BAYLARIAN PLAT W. MODS 1831 BAYLARIAN BLVD.

Updated: January 10, 2017

Minor Subdivision Plat w. Modification of Standards

2016 SURVEY

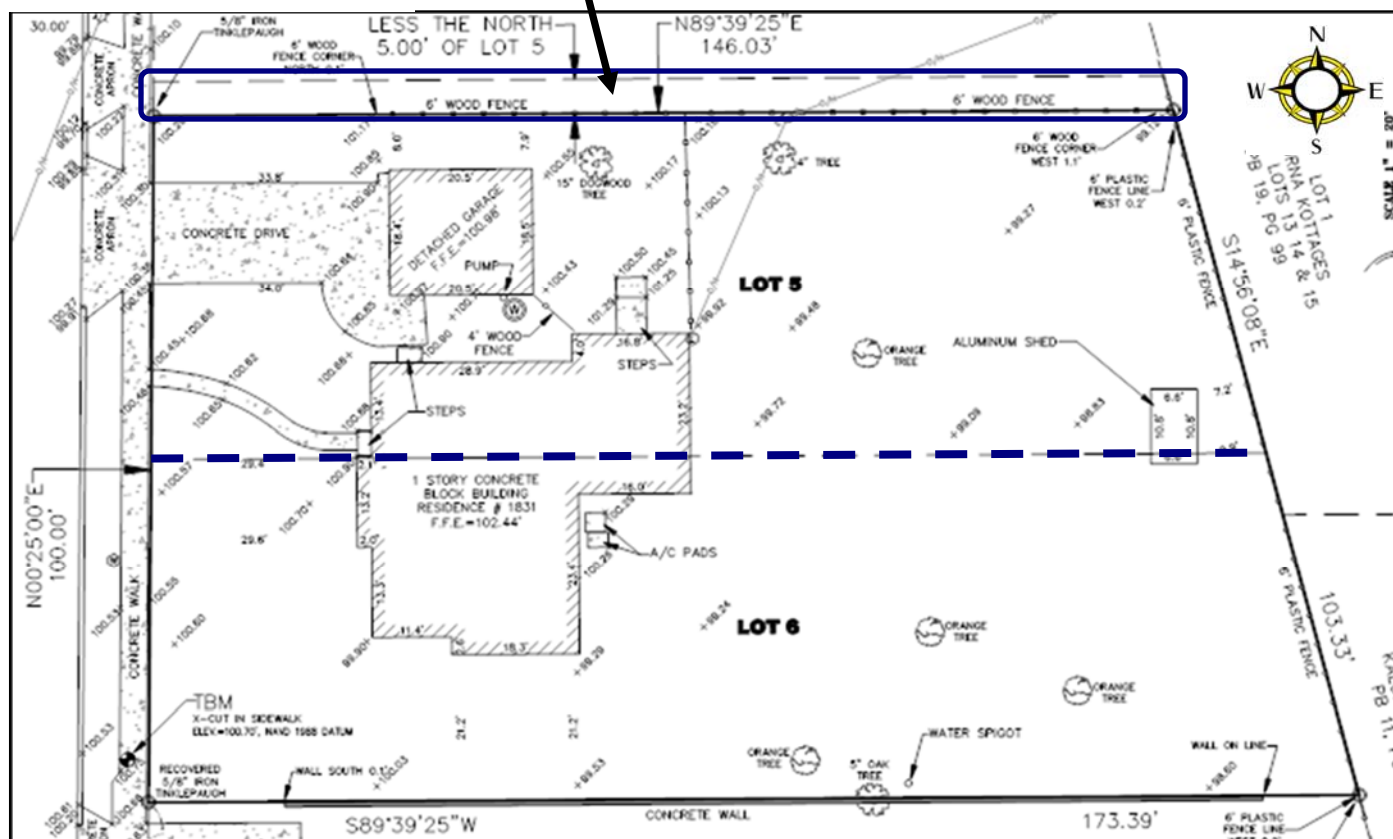
Northerly 5 ft. of Lot 5 part of Lot 4 prior to 1959 (negates possible revert to plat)

PROPOSED SITE PLAN W. NEW HOMES

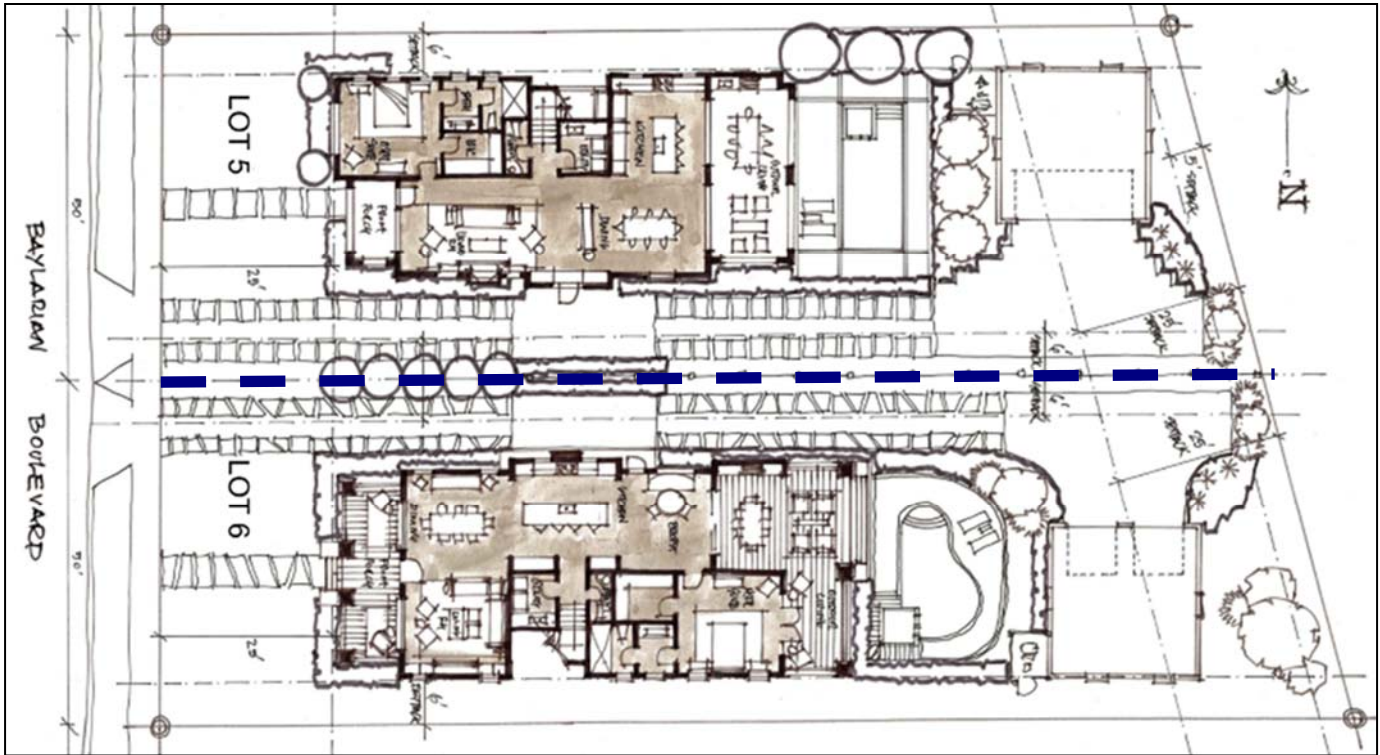
2. *Nonconforming Lots* - Per the site plans provided within the staff report, the garages for the two (2) lots shall be detached and located at least 5 ft. wall to wall or eave to eave, whichever is greater, east of the new homes.

3. *Garage Setbacks* - The detached single-story garages for both lots shall be setback at least 5 ft. from the rear lot line and at least 6 ft. from the north or south side lot lines.
